Memorandum

Date: June 3, 2024

Re: Re-submittal of Site Plan, 9610 and 9630 Universe Boulevard NW (PR-2020-004024/SI-2024-00648)

The following memo provides responses to staff comments for the Site Plan Administrative application heard on May 16, 2024. Staff comments are in italic followed by the Applicant responses.

SITE PLAN

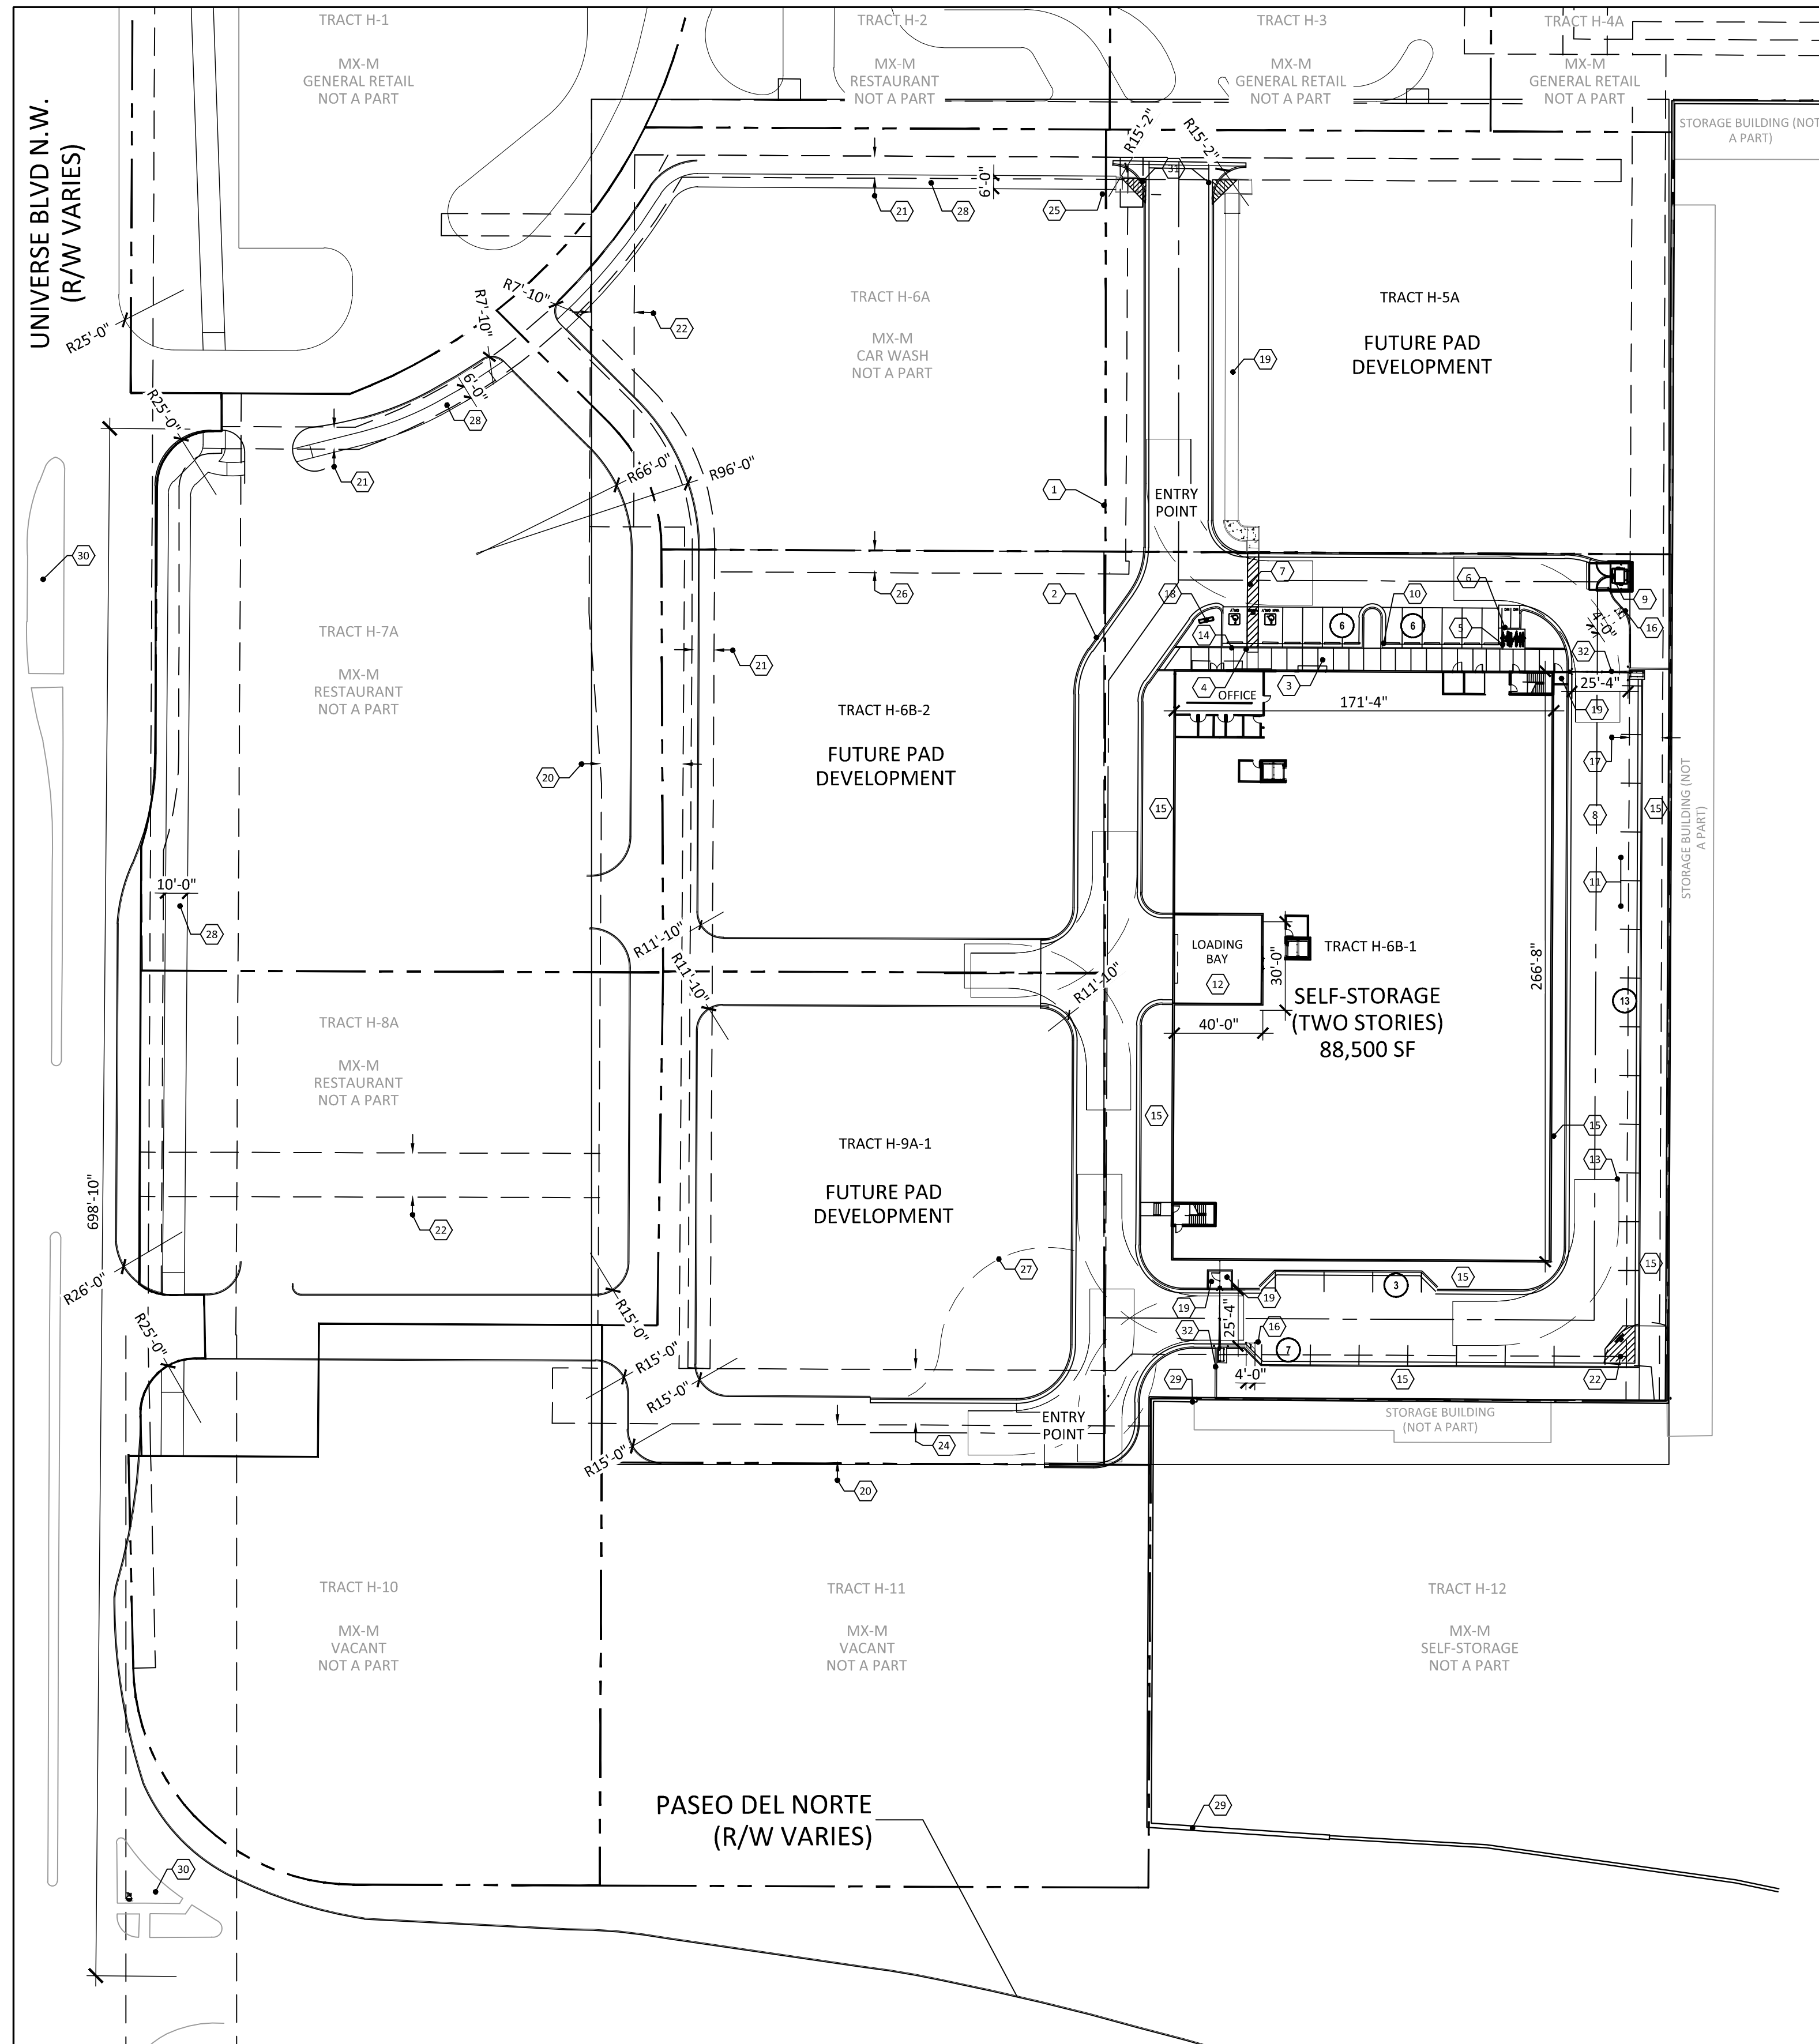
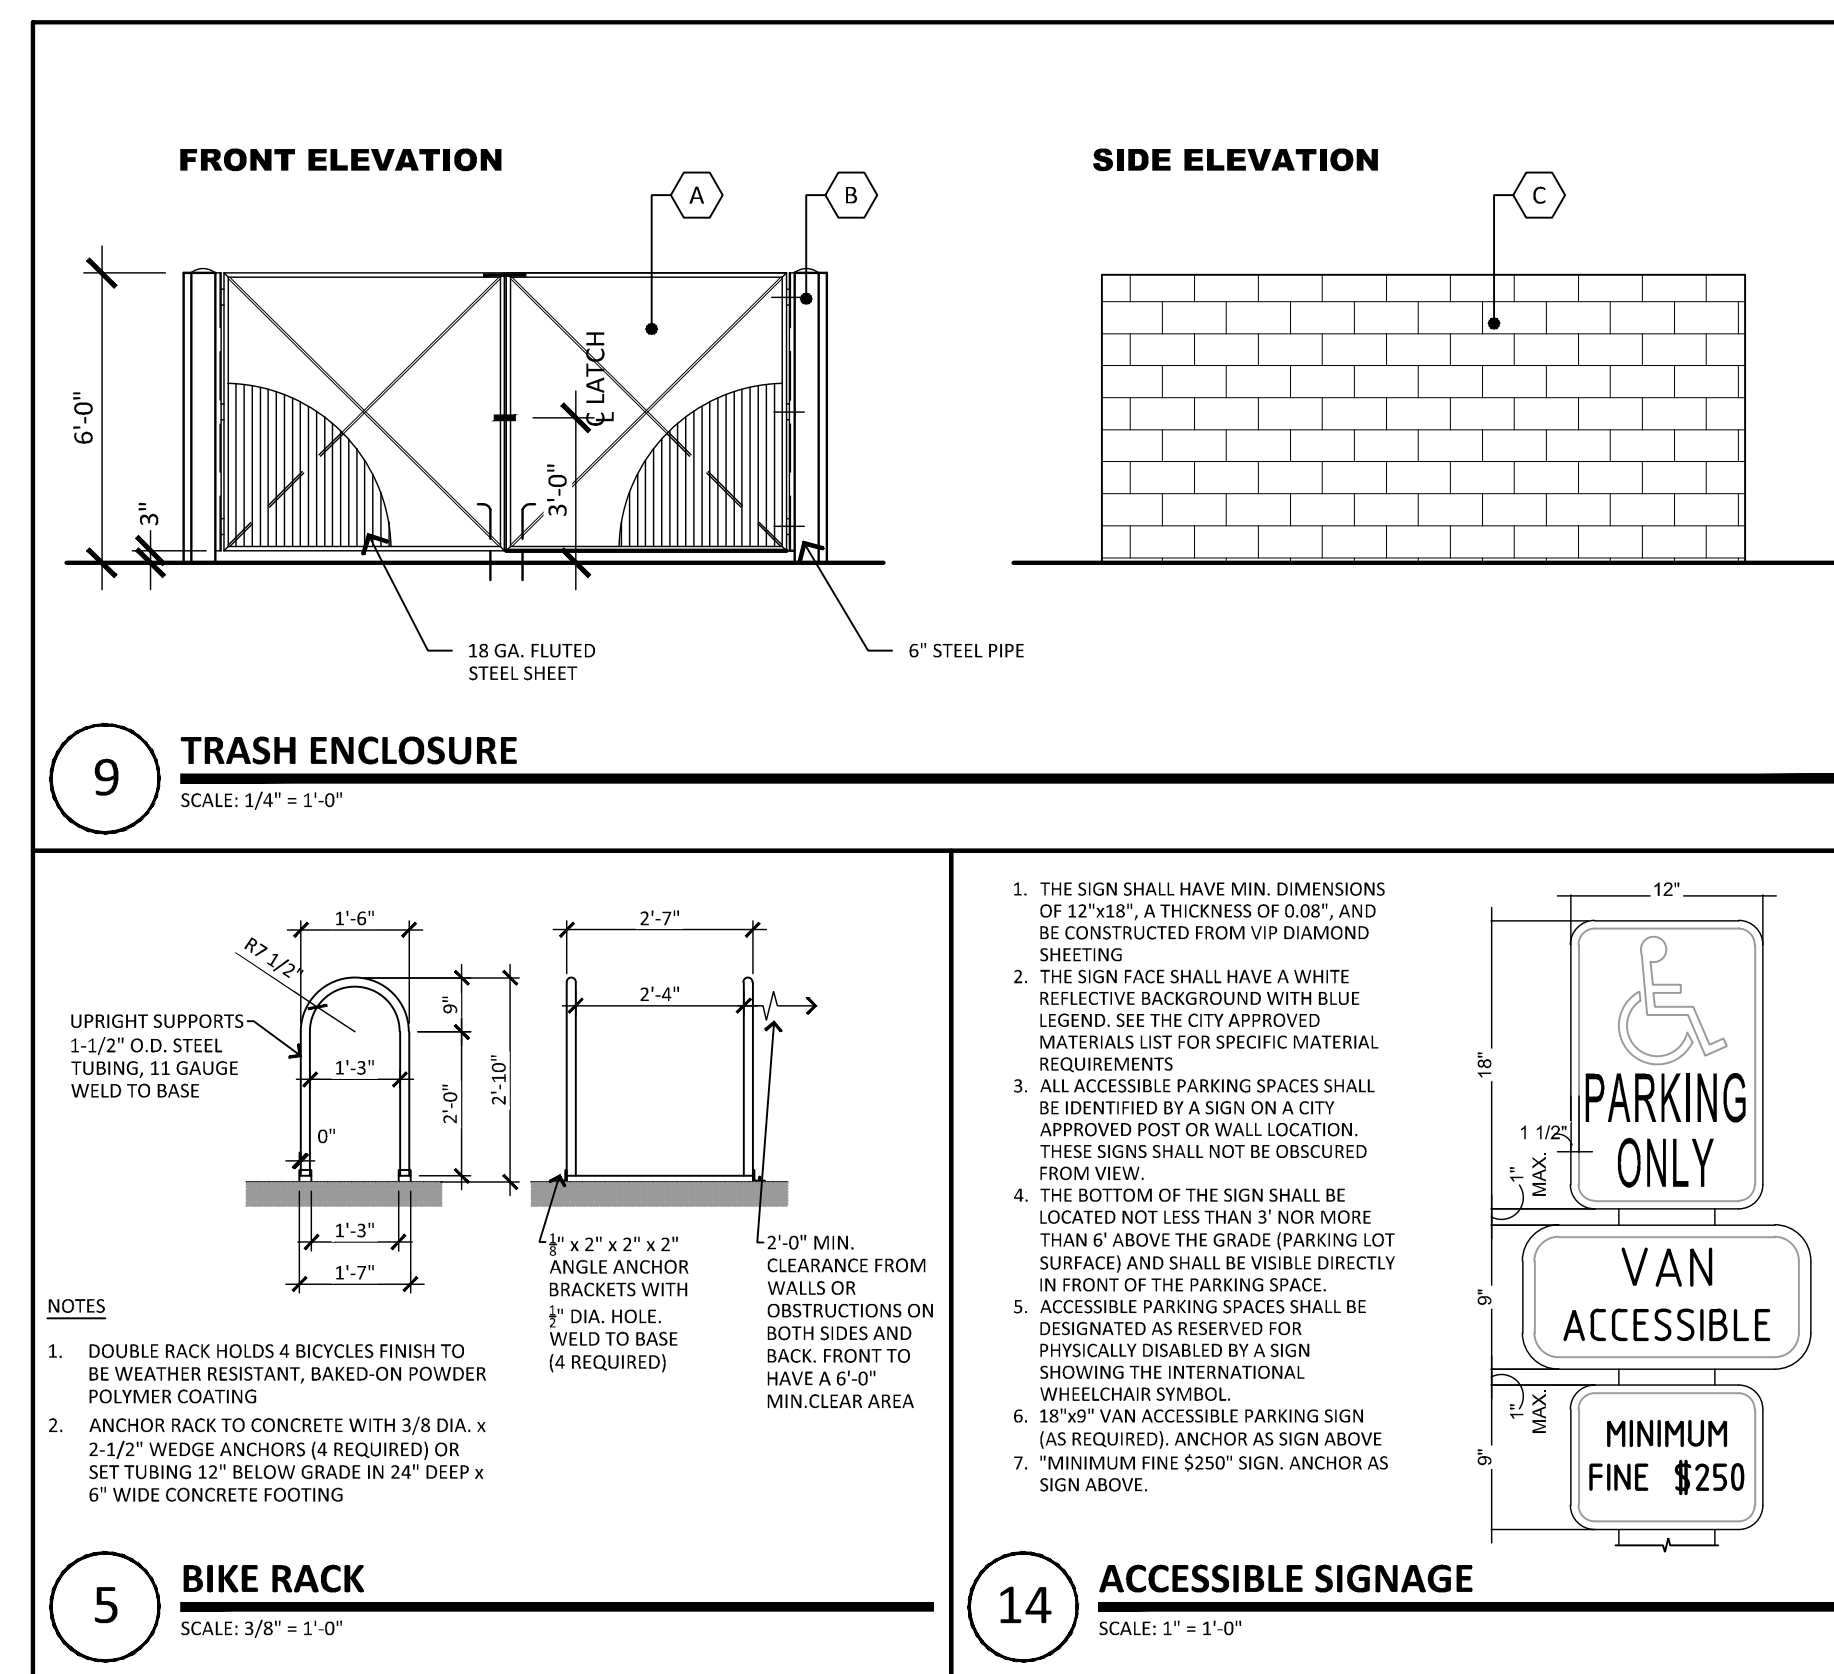
*A lighting plan was included in the submittal and there does not appear to be any spillage across property lines. *Per the Use Specific Standards for Self-Storage, clarify internal and external lighting plan during off hours. The site is within 200 feet of a residential zone and does have visibility from both Universe and Paseo del Norte.*

Given the Character Area of the Petroglyph National Monument, please add a note to the site plan restricting continuous indoor light visible from the building windows from dusk to dawn. Motion sensor lights are a successful alternative because the lights turn on only when someone is in the

building. Please do not light up brightly colored faux doors in windows, or other trademark related signs/symbols which would effectively function as unauthorized "signage" for the development.

Applicant Response: A note was included on the Site Plan that states "Lighting for the interior faux windows will be off between 10:00 PM and 7:00 AM. Lighting is compliant per IDO Section 4-3(D)(29)(E). All lighting will comply with the New Mexico Dark Skies Ordinance. There is no façade lighting facing east, toward the nearest residential zone or the Petroglyph National Monument.

Applicant Response: As stated above, the note on the Site Plan states that lighting will be off between the hours of 10:00 PM and 7:00 AM. The faux doors in the windows are not brightly colored, which will contribute to reducing the brightness. The façade lighting does not face east, protecting the Petroglyph National Monument.

- LIGHTING FOR THE INTERIOR FAUX WINDOWS WILL BE OFF BETWEEN 10:00 PM AND 7:00 AM. LIGHTING IS ALSO COMPLIANT PER IDO SECTION 4-3(D)(29)(E). ALL LIGHTING WILL COMPLY WITH THE NEW MEXICO DARK SKIES ORDINANCE.
- THE ELEVATION FACADES COMPLY WITH THE DEVELOPMENT STANDARDS FOR THE MX-M ZONE DISTRICT CONTAINED IN IDO SECTION 5-11-(E) AND THE STANDARDS FOR VPO-2 CONTAINED IN IDO SECTION 3-6(E)(5)-(7).

A1 LANDSCAPE PLAN

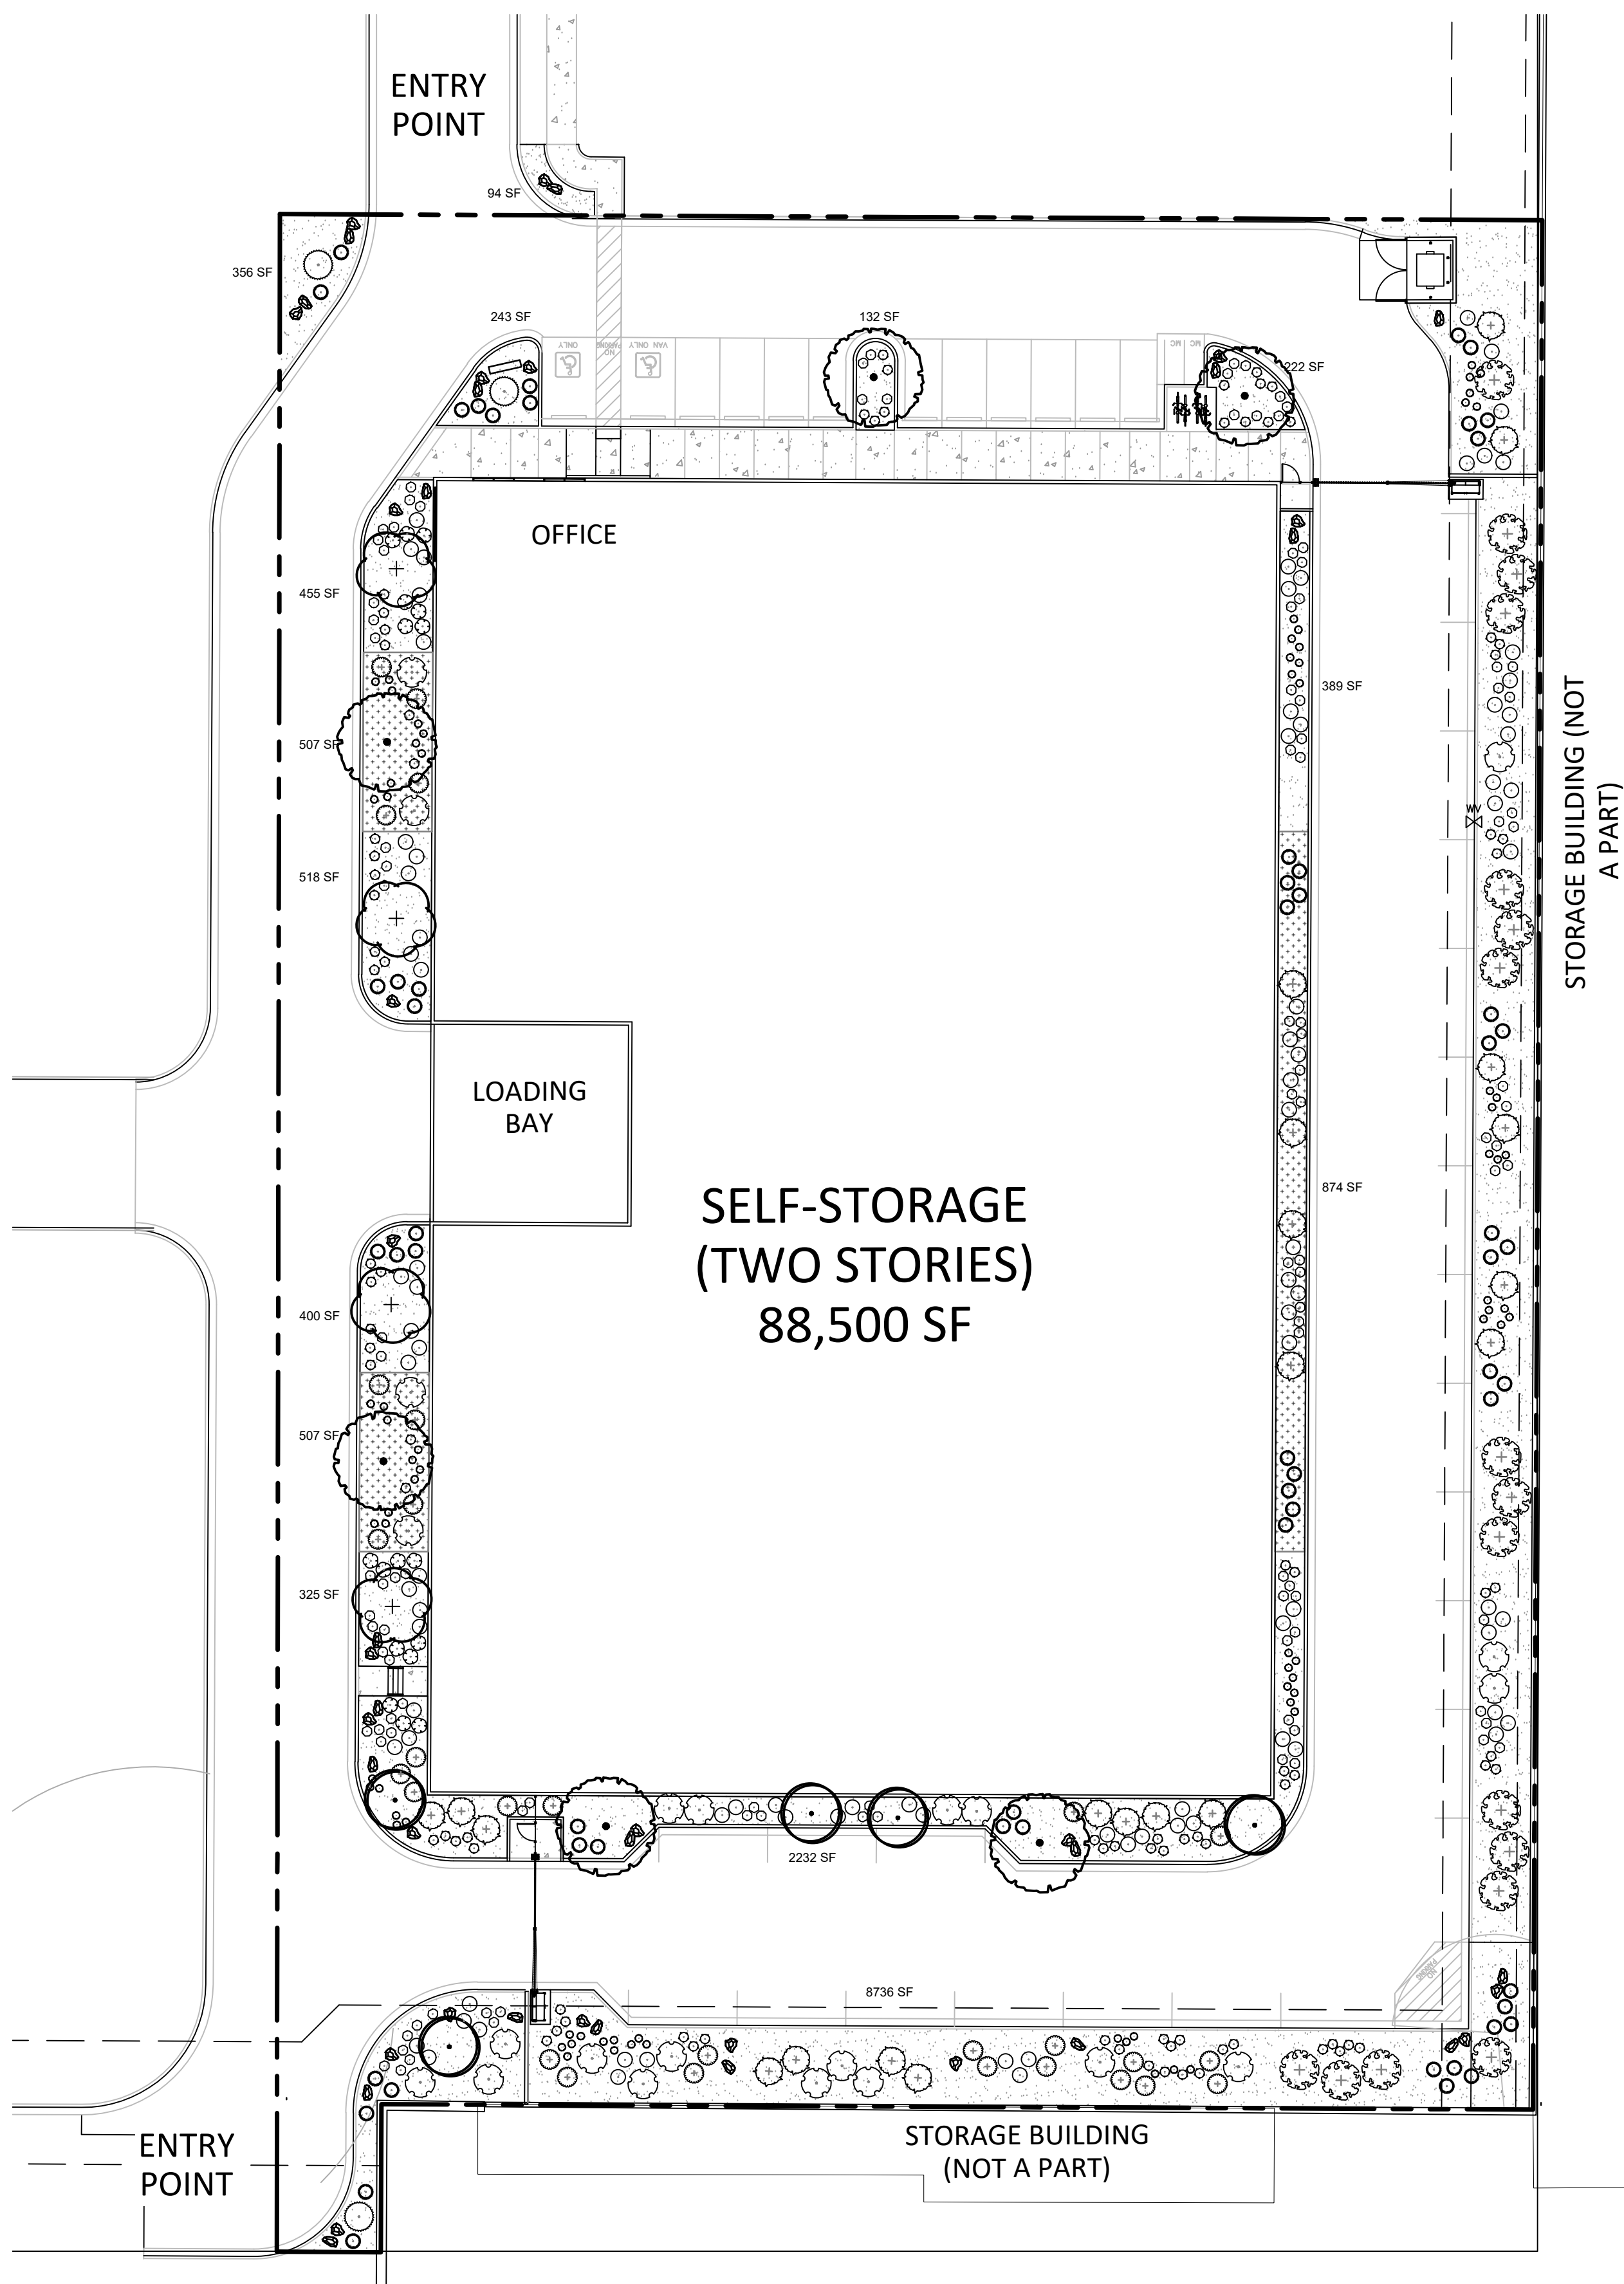
*Per 5-6(C)(2)(a) a minimum of 15% of the net lot area of each development shall contain landscaping. Those calculations are included in the submittal. In a resubmittal explain/demonstrate how all relevant sections within 5-6 are being met. Including but not limited to 5-6-C General Landscaping, 5-6-C-2 Minimum Landscape Area, 5-6-D Required Street Trees, 5-6-E-2 Minimum Landscape Area, 5-6-E-2 Development next to Low Density Residential, 5-6-F Parking Lot Landscaping, 5-6-G Equipment/Support Areas. * Include detail for pedestrian connections per IDO 5-3.*

Applicant Response: Agreed. Notes were added to the Landscape Plan for the above criteria. A pedestrian connection detail was added to the Landscape Plan showing landscape at the pedestrian connection into the site.
